Handouts from NRC - 7 Pages

PUBLIC MEETING - JULY 11, 2005 NFPA 805 REGULATORY GUIDE ACRS COMMENTS

ACRS COMMENTS (Ref. June 14, 2005 letter; ML051650432)

Public Meeting - July 11, 2005
NFPA 805 Regulatory Guide
Handouts from NEI - 5 Pages
Consistency with RG 1.174

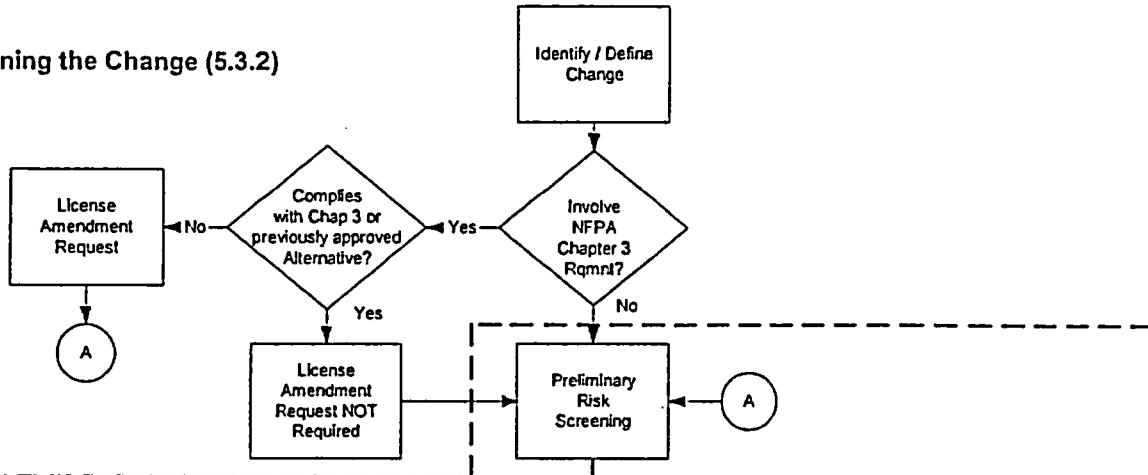
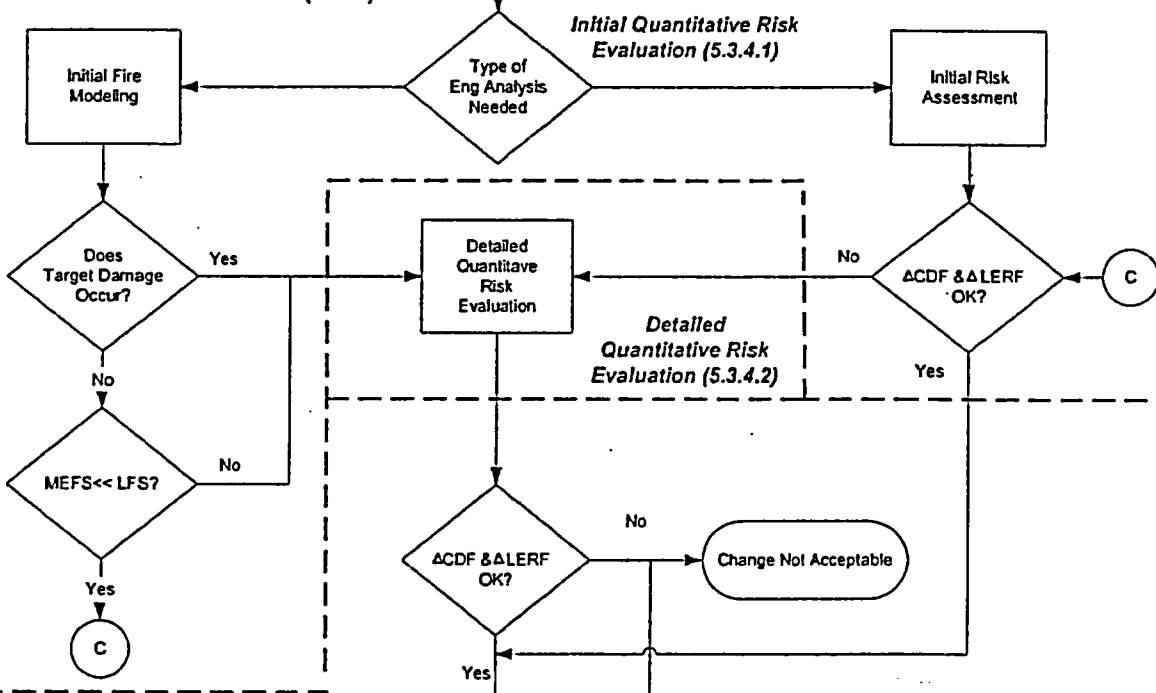
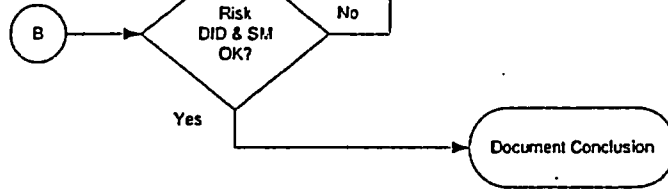
4. Section 5.3.1, first of 2 bullets at bottom of page 42: change "approved by the AHJ" to "accepted by the AHJ"
5. Figure 5-1: Discuss proposed Staff changes and agree on final configuration.

1. The "initial fire modeling" approach should not be used as an alternative to estimates of changes in core damage frequency (ΔCDF) and large early release frequency ($\Delta LERF$). Identification of a success path does not necessarily assure that ΔCDF and $\Delta LERF$ are negligible (Section 5.3.4.1 of NEI 04-02).
2. The definitions of MEFS and LFS in NFPA 805 and NEI 04-02 are sometimes confusing and contradictory.

1. Proposed edits to Section 5.3.4.1 of NEI 04-02
 - Modify Figure 5-1 to indicate that initial fire modeling requires a $\Delta CDF / \Delta LERF$ assessment. See attached.
 - Modify Section 5.3.4.1. Divide into 3 subsections:
 - 5.3.4 Quantitative Risk Evaluation
 - 5.3.4.1 Initial Quantitative Risk Evaluation
 - 5.3.4.1.1 Initial Fire Modeling Assessment
 - 5.3.4.1.2 Initial Risk Assessment
 - 5.3.4.1.3 Acceptability Determination for Initial Quantitative Risk Evaluation
 - 5.3.4.2 Detailed Quantitative Risk Evaluation
